Subject: **FLICKER, WHITE BALANCE CHANGE**

Model: **PVM-8040**

Serial No: **2,000,001-2,012,000**

**Figure 1**

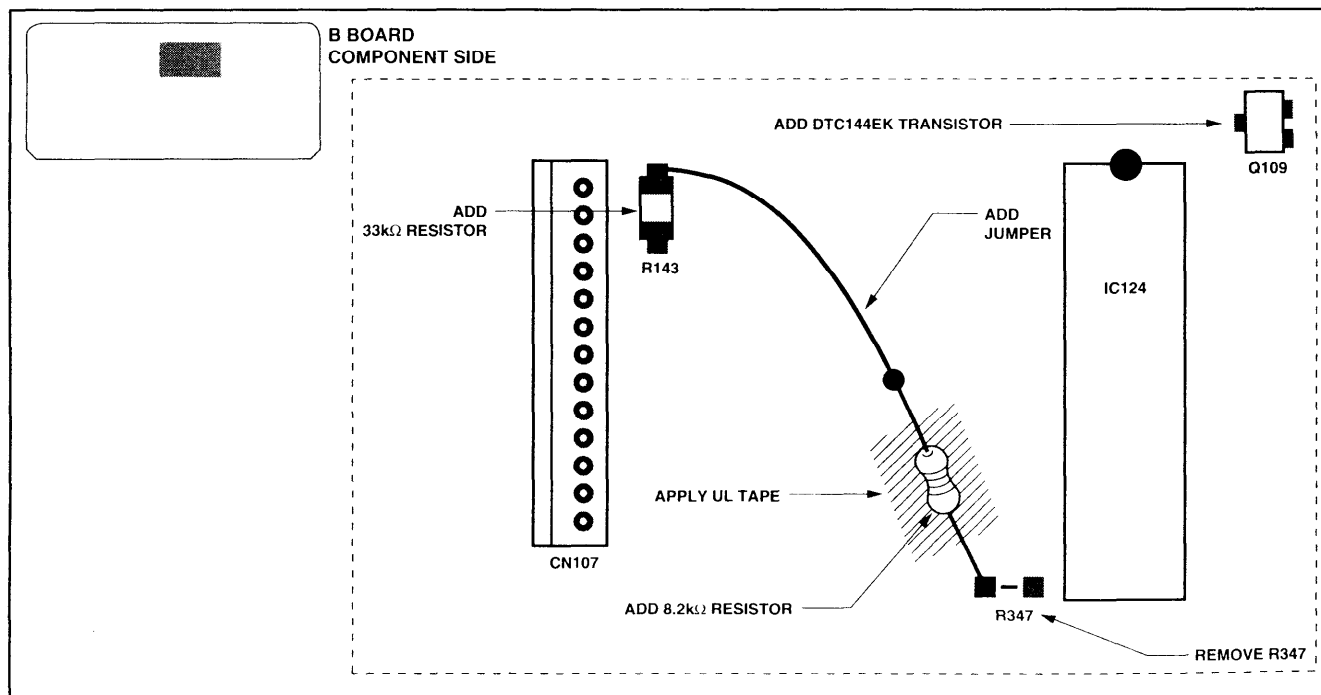
**B Board, Component Side (See Figure 1.)**

1. On upper right side of IC124 (near R129, R369), solder DTC144EK transistor to the Q109 trace.
2. On right side of CN107, solder a 33kΩ resistor to the R143 trace.
3. Remove R347 (lower left side of IC124).
4. Solder 8.2kΩ resistor between R347 and R143 (shown in Figure 1). Add jumper wire for extension.
5. Apply UL tape to 8.2KΩ resistor to protect components.

Figure 2

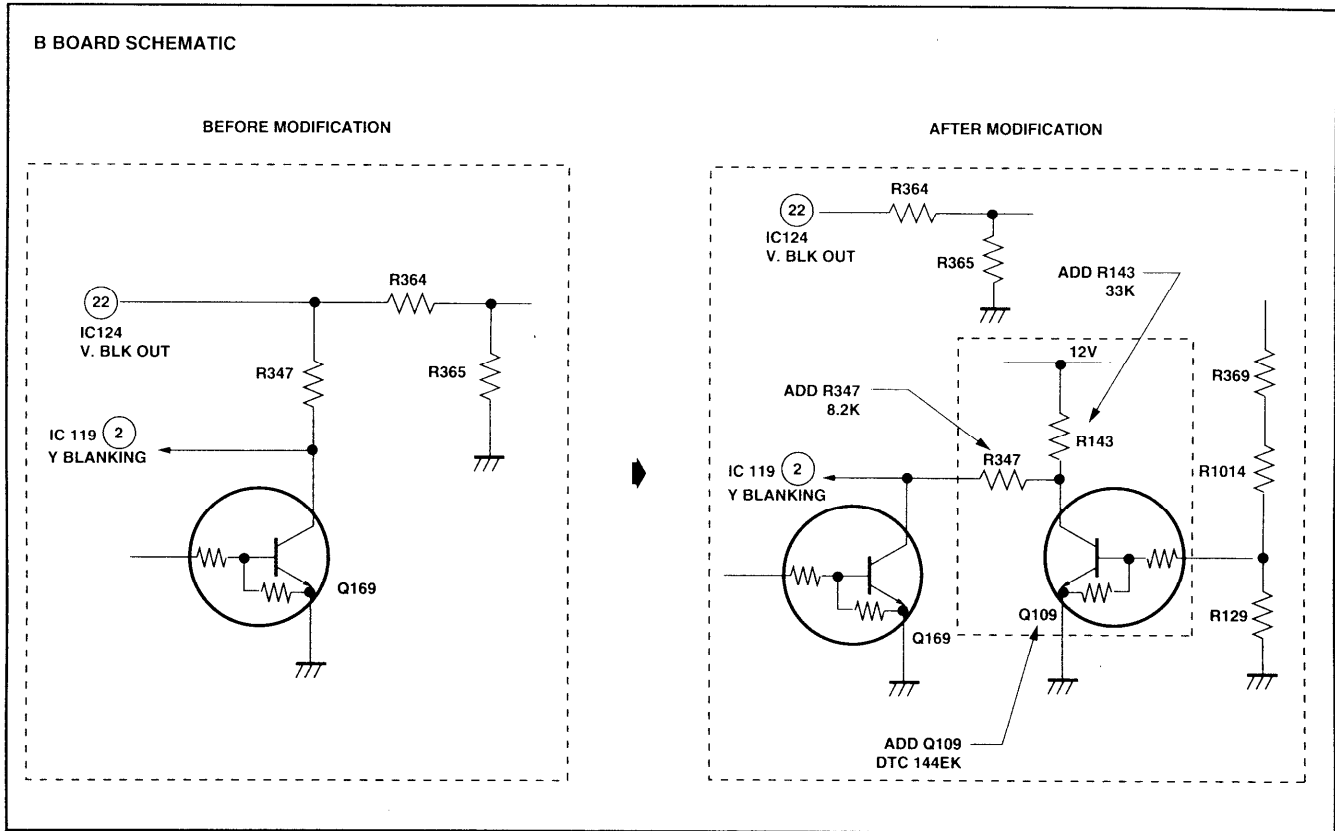
The before and after modification is shown on the B Board Schematic drawing in Figure 2.
